SERVICE No. 706B BULLETIN

October 9, 1991

Tail Brace Wire Support Installation

REASON FOR REVISION: Add Vero Beach manufactured airplanes.

SKETCH A

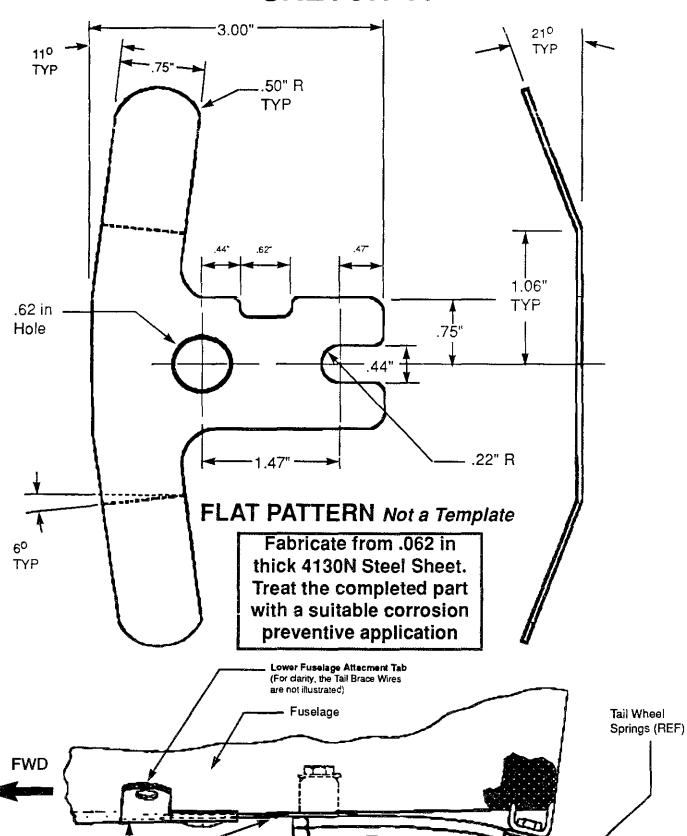
Reports have been received of failure of the lower horizontal stabilizer brace wire fuselage attachment tab. This tab connects the lower horizontal stabilizer brace wire to the lower fuselage. Separation of the tab and subsequent loss of brace wire support could result in damage to the stabilizer and possible loss of control.

This Service Bulletin provides instructions for the installation of an additional support plate to strengthen the attachment mechanism.

- 1. a. For PA-18-150 Super Cub aircraft, Serial Numbers 18-8602 through 18-18-8109013 only, fabricate a support plate from .062" thick 4130 N Steel sheet (6.5" x 3.0") using the template shown on sketch "A", or procure one each, Piper Part Number 60764-02 or Piper Part Number 60764-03 Support Plate.

- 7. Using the existing holes in the lower fuselage attachment tabs as a guide, drill two .191 inch holes thru the new support plate for attachment of the lower horizontal stabilizer tail brace wires.

Longer bolts (Piper Part Number 400-440 / AN3-6A) may be required to insure proper engagement of the self locking nuts. Also, the tail wheel spring bolt slot in the support plate may be relieved up to an additional .125" to compensate for alignment variances.
